Seabrook Station

Response to Request for Additional Information Regarding
License Amendment Request 12-04, Cold Leg Injection Permissive

Response to Request for Additional Information (RAI)

P-15 Permissive Block Diagram

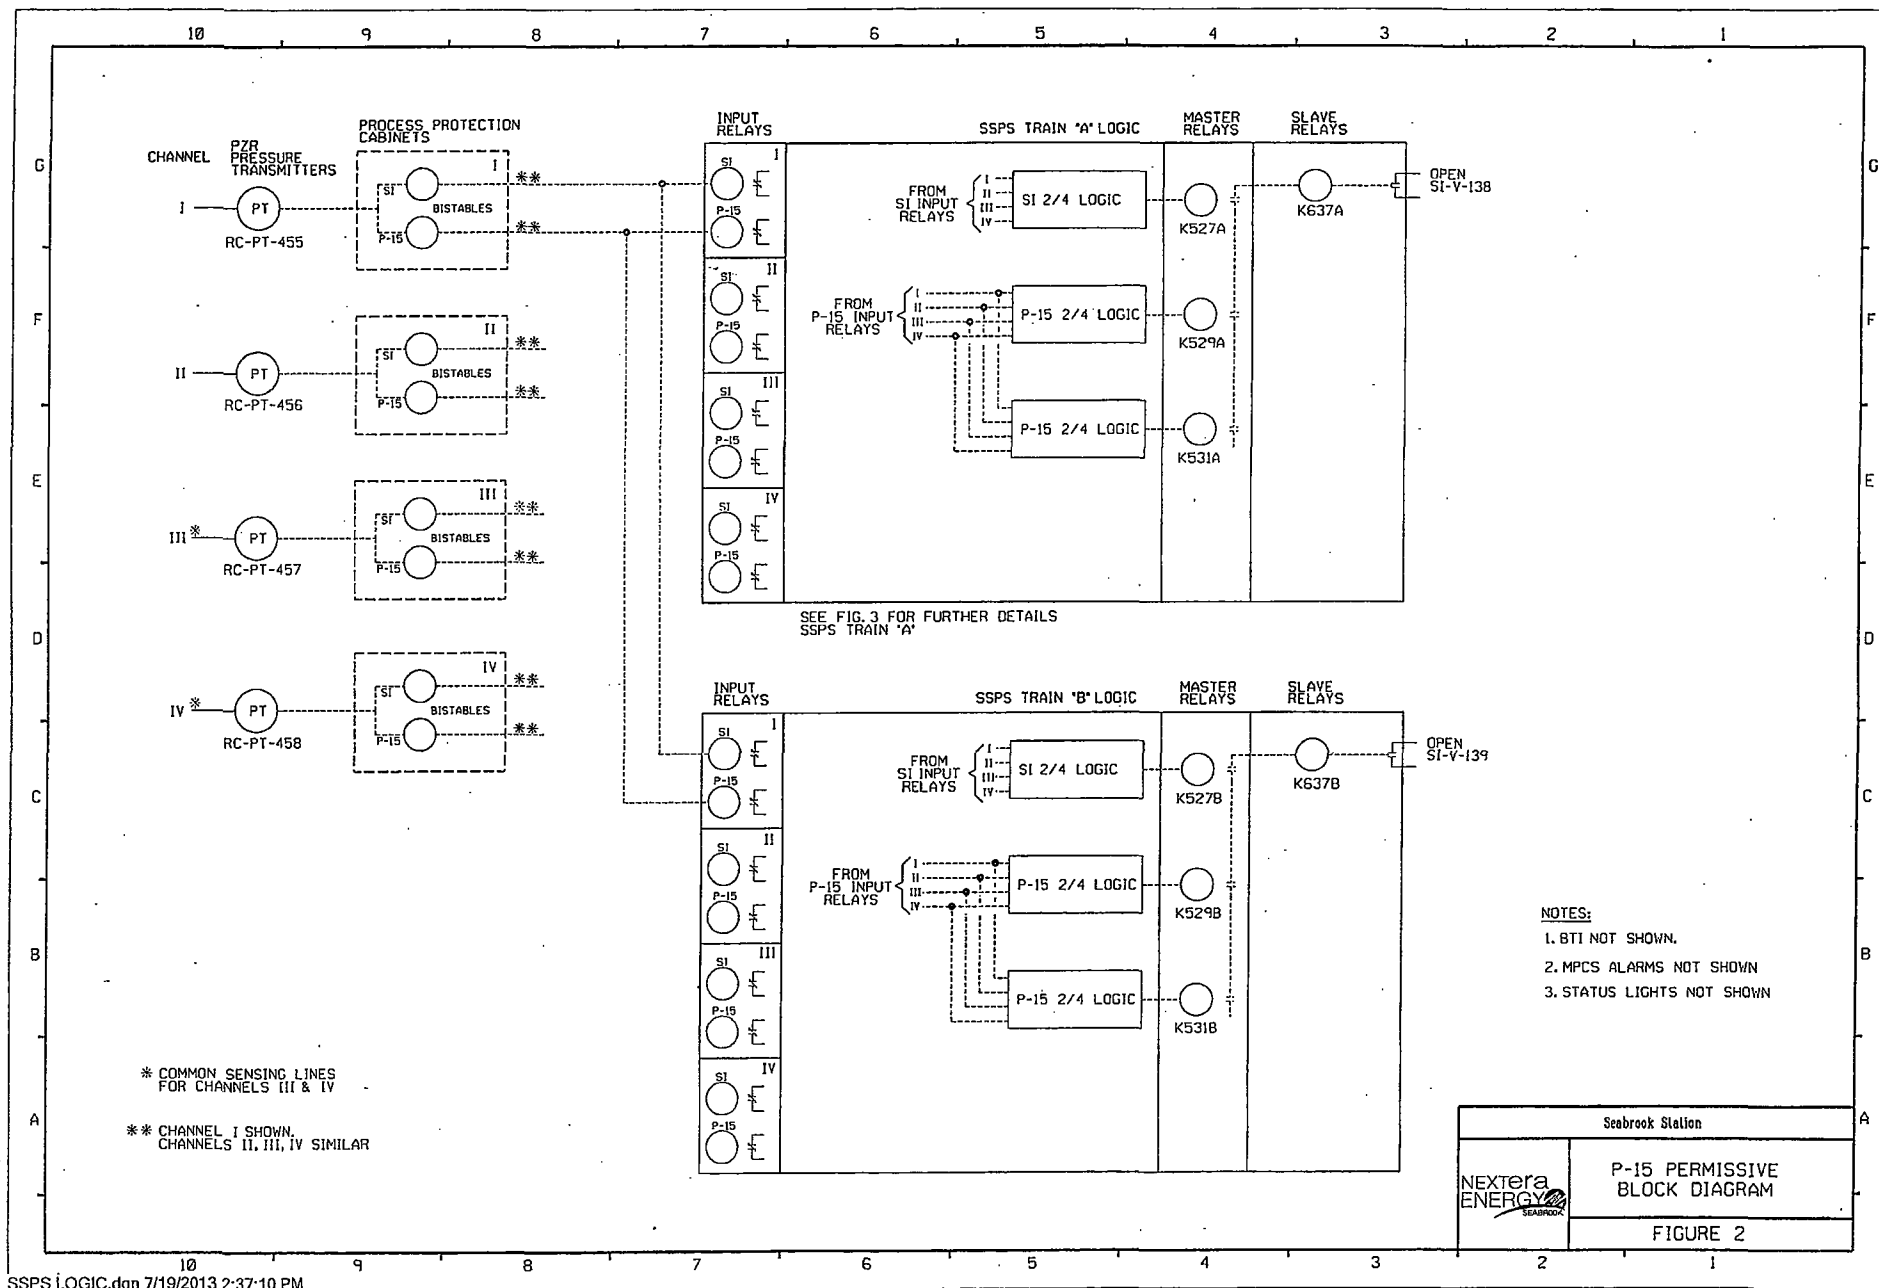
Clarify whether the LAR's simplified P-15 cold leg injection permissive (CLIP) logic diagram (ADAMS Accession No. ML 13079A 122, Attachment 1, Figure 1, Page 5) shows the solid state protection system (SSPS) coincidence logic for only one SSPS train, which is duplicated for the other SSPS train, or does it show the SSPS coincidence logic of both SSPS trains.

Demonstrate the post-modification allocation of P-15 functions and S-signal functions among the equipment and components related to the P-15 function (e.g., SSPS components, cabinets, channels, trains, actuated devices and the electrical division/separation group associated with each, etc.).

- a. Clarify whether these *two relays* are in series or are in parallel with one another prior to being in series with an S-signal relay;
- b. Clarify whether there are *two relays* (i.e., redundant relays) within each SSPS train, or one-relay in one SSPS train, and another relay in the other SSPS train;
- c. Provide the location(s)/cabinets(s) where the series connections between these *two relays* and the S-signal relay(s) is/are made;
- d. Clarify whether each SSPS train affects the S-signal relays for both cold leg injection valves (1-SI-V-138 and 1-SI-V-139), or only a single cold leg injection valve that is associated with one of the two SSPS trains.

The CLIP Logic Diagram (Figure 1 in License Amendment Request 12-04) shows the signals from the four existing pressurizer pressure channels (which are not train-related) providing signals into two 2/4 logic gates. These gates are train-related; only one train is shown on Figure 1 for simplicity. The two 2/4 gates provide the signal to the AND gate, the output of which is the P-15 permissive on a per train basis. Alarms points D8187 & D8188 are common to both trains; the signals from both trains are isolated and input to the computer demultiplexer, which generates these alarms. UL-1-198 is the P-15 permissive status light on the main control board, which receives its input from the control board demultiplexer.

Refer to Attachment 1, which is an overall block diagram for the P-15 permissive from the pressurizer sensing lines to the slave relays which actuate the high head safety injection (SI) valves, SI-V138 and V139.

Refer to Attachment 1, P-15 Permissive Block Diagram, and Attachment 2, Cold Leg Injection Permissive P-15, which provides additional detail of the implementation of P-15 on train A of the SSPS. The pressurizer pressure transmitters, process protection and SSPS SI components are existing. The components depicted for the P-15 function are new.

3. a) The contacts from the two new master relays associated with the P-15 function are in series with each other and are in series with the existing contact from the S-signal master relay. See Attachment 2.
- b) There are two master relays associated with the P-15 function in each train. See Attachment 2.
- c) The electrical connections between these two slave relay contacts and the S-signal relay contact are made in the SSPS output relay cabinet. See Attachment 2.
- d) As shown in Attachment 1, each train affects its own associated cold leg injection valve. Train A only is shown in Attachment 2.
